**PURPOSE**

There has been a change in the supplier of the start capacitor used on Single Phase SC1000/SC1500 units, implemented to help reduce overall cost to customers. As a result of this change, the new capacitor differs in physical size and can no longer be mounted to the motherboard in the same manner as the previous version. This change required a new part number to be assigned to the updated capacitor.

SC1000/1500

5220 MOTHERBOARD ASSY;1PH

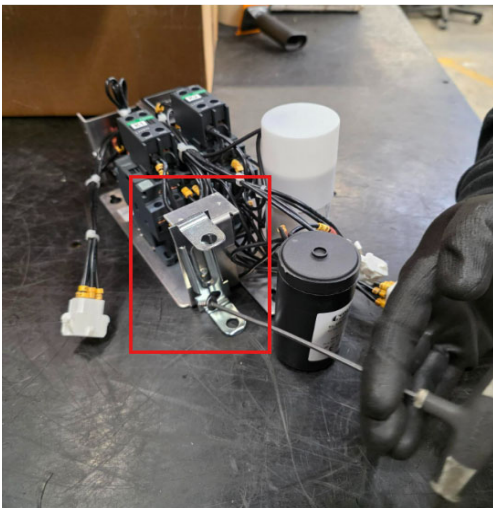
Due to a significant size difference between the legacy capacitor (P/N 5882) and the updated capacitor (P/N 726182-1), a minor modification is required to ensure proper fitment. When replacing P/N 5882 with P/N 726182-1, the new capacitor must be installed in the existing location and securely fastened to the motherboard bracket using an approved securing method. Refer to the procedure below for detailed installation instructions.

Using a 4 mm T-handle, remove the capacitor bracket housing P/N 5882 as shown below.

Once the bracket is removed, secure the new capacitor (P/N 726182-1) to the existing bracket using cable tie (P/N 5851), as shown below. Ensure the excess cable tie stem is trimmed flush after installation.
